**AMENDMENTS TO THE DRAWINGS:**

### **REMARKS**

SELWAY, James W.  
Appl. No. 10/530,011  
Response to Office Action dated August 22, 2006

Figure 1

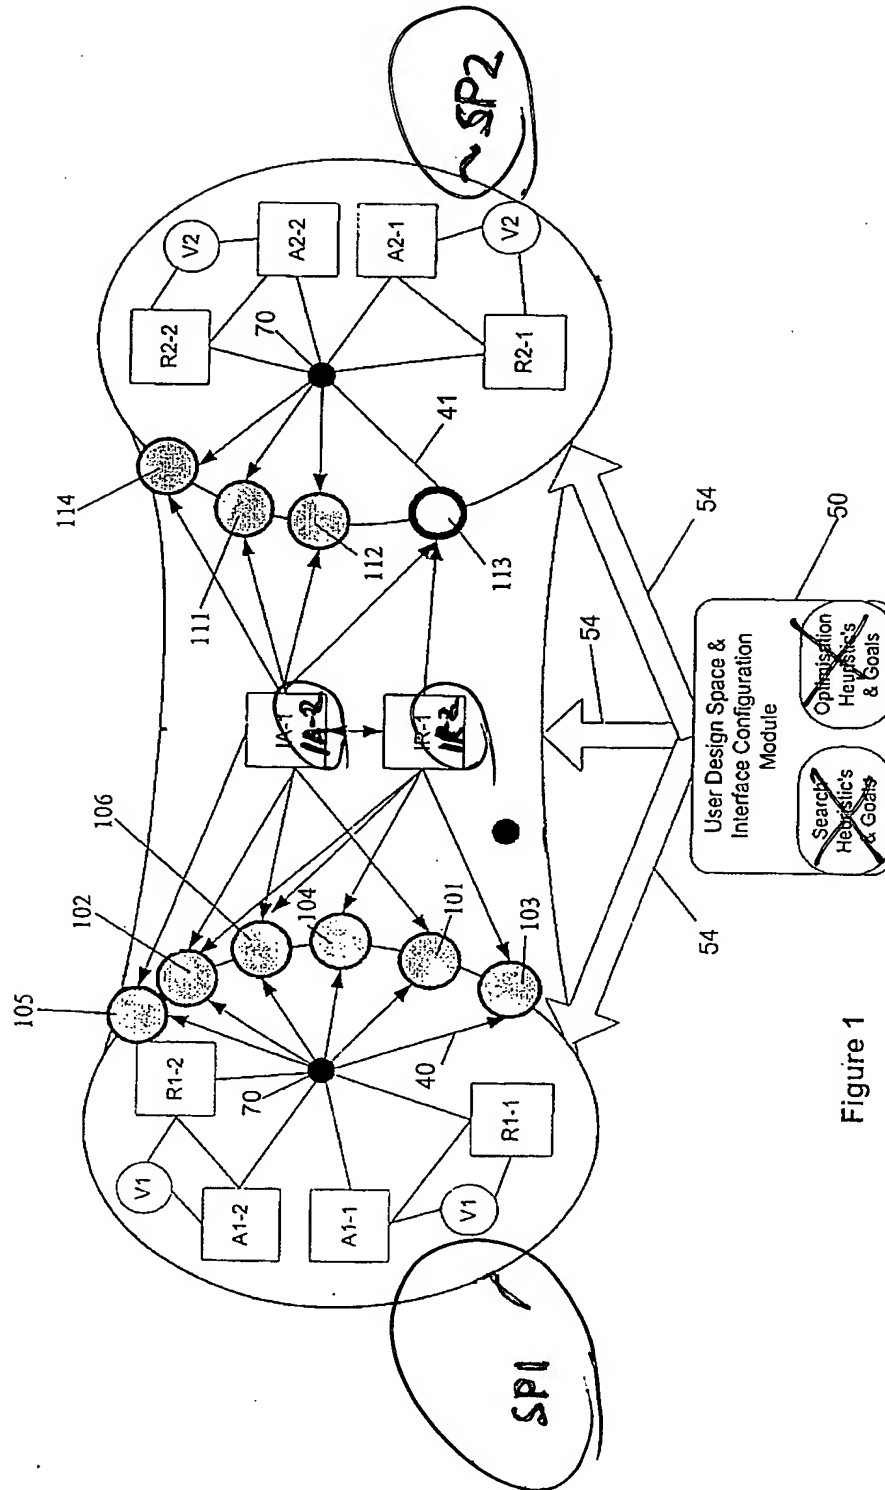
Figure 1 has been marked to show subprocesses 1 and 2 as SP1 and SP2. The second interface algorithm in the second interface rule IA-2 and IR-2 were omitted from original Figure 1. These are shown as co-located with IA-1 and IR-1 in amended Figure 1. In Figure 2, reference numeral 58 has been added and reference numeral 59 has been moved.

With respect to the objection to the drawings as allegedly failing to include certain reference sign(s) mentioned in the description as set forth in item 4 of the office action, the specification at page 12, line 27 has been amended to refer to "the second subprocess (SP2)" and Figure 1 has been marked to show subprocesses 1 and 2 as SP1 and SP2. The second interface algorithm in the second interface rule IA-2 and IR-2 were omitted from original Figure 1. These are shown as co-located with IA-1 and IR-1 in amended Figure 1. In Figure 2, reference numeral 58 has been added and reference numeral 59 has been moved. Finally, reference numeral 1 mentioned on page 22, line 36 has been changed to SP1.
